ADDENDUM NO. 9

PROJECT NO. DGS C-0503-0027 PHASE 001

PROJECT TITLE - Danville State Hospital - Replace Steam Generation Equipment

2 RISER DIAGRAM - NEW (BASE BID 2)
 E-7 NO SCALE

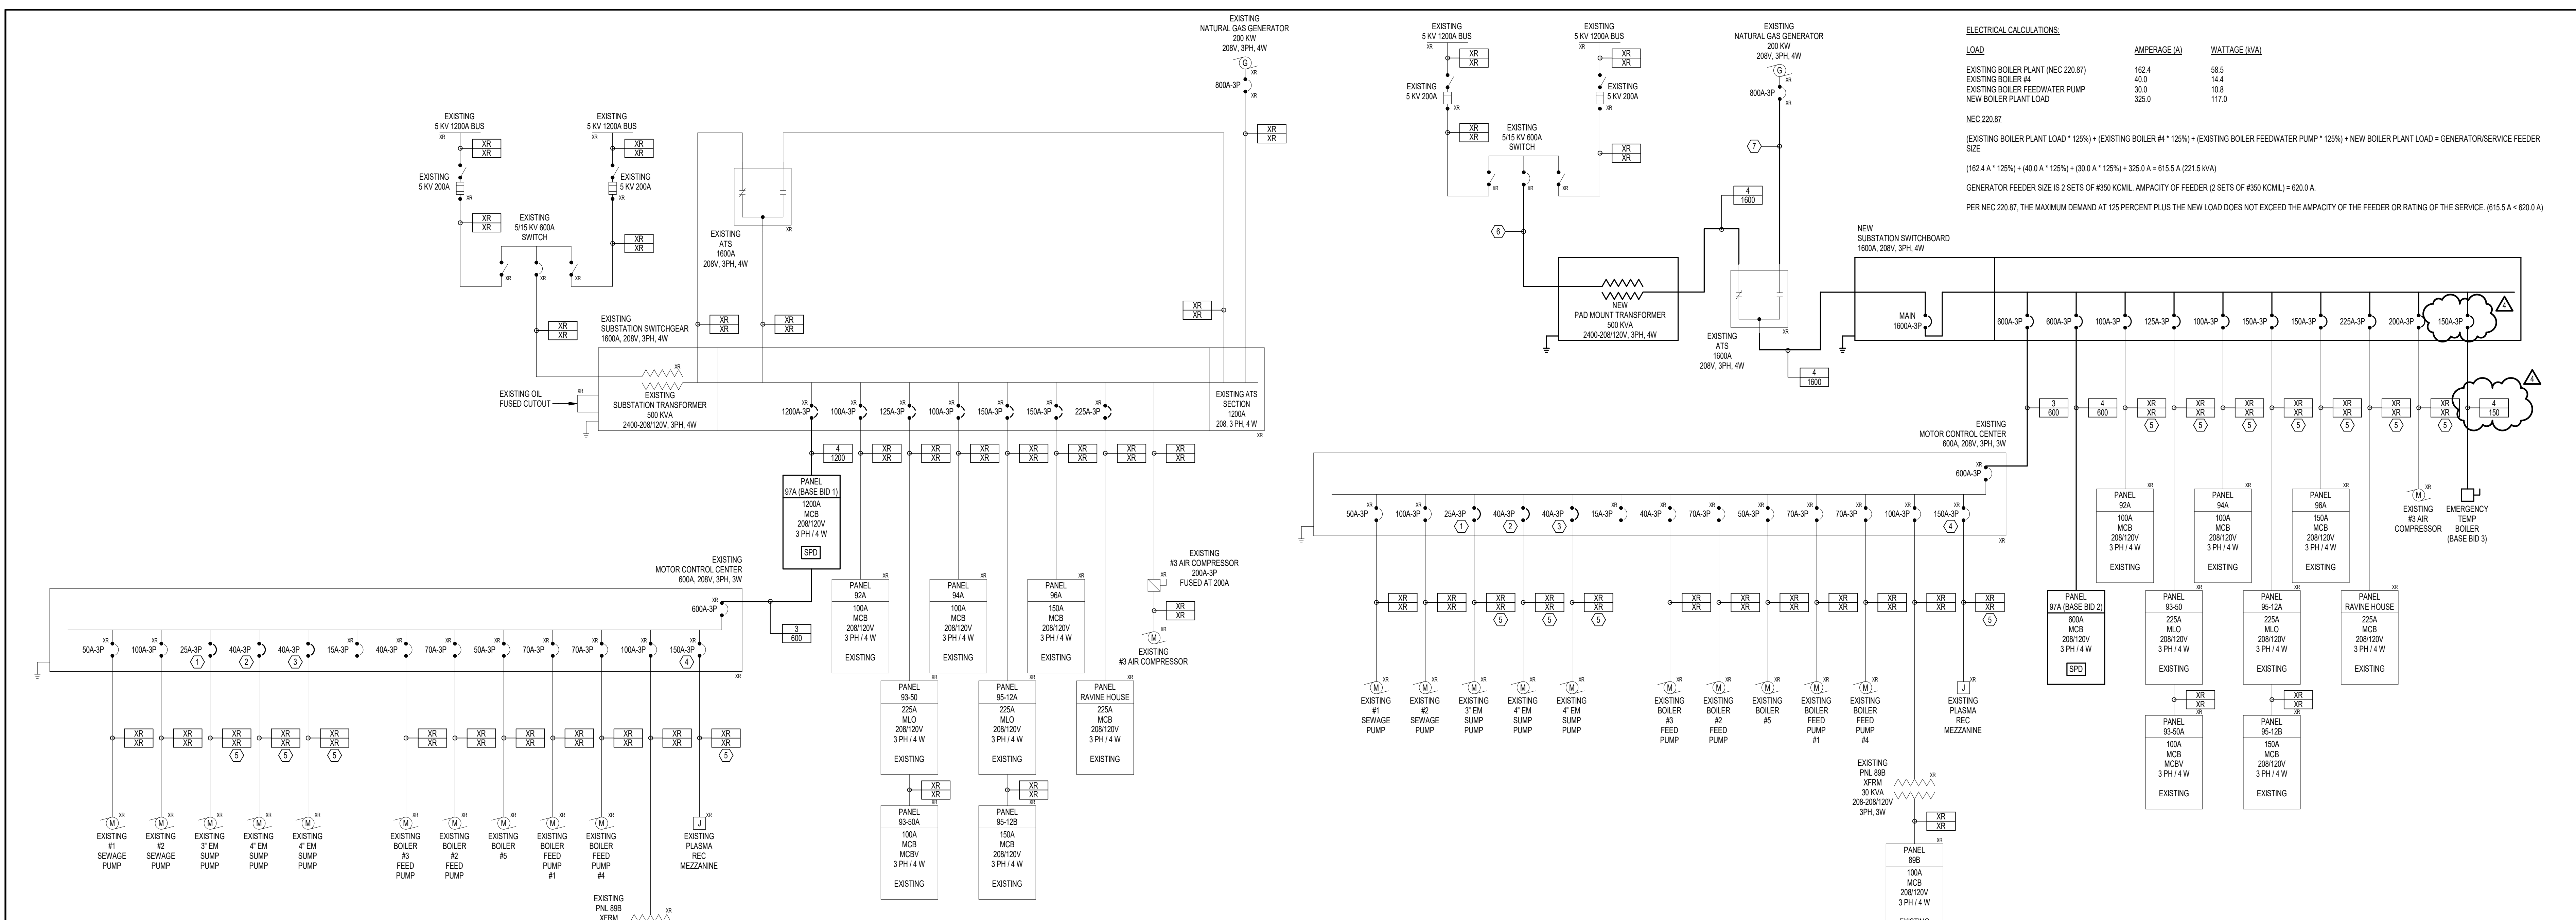
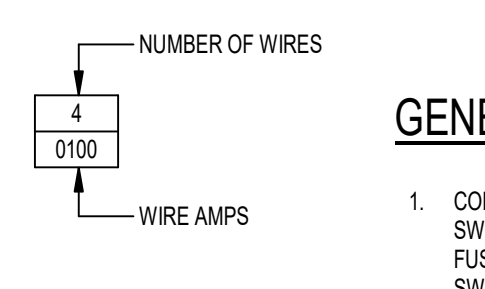
Item 1 - Drawing E-7, Riser Diagram – New (Base Bid 2) breaker and wire/conduit feeder sizing has been updated from 100A to 150A to match fused disconnect ratings of Temp Boiler Disconnect on sheet E-4. Drawing E-8, Switchboard: Substation Switchboard Schedule breaker frame and trip rating have been updated from 100A to 150A (trip rating) and 125A to 225A (frame size) to match fused disconnect ratings of Temp Boiler Disconnect on sheet E-4.
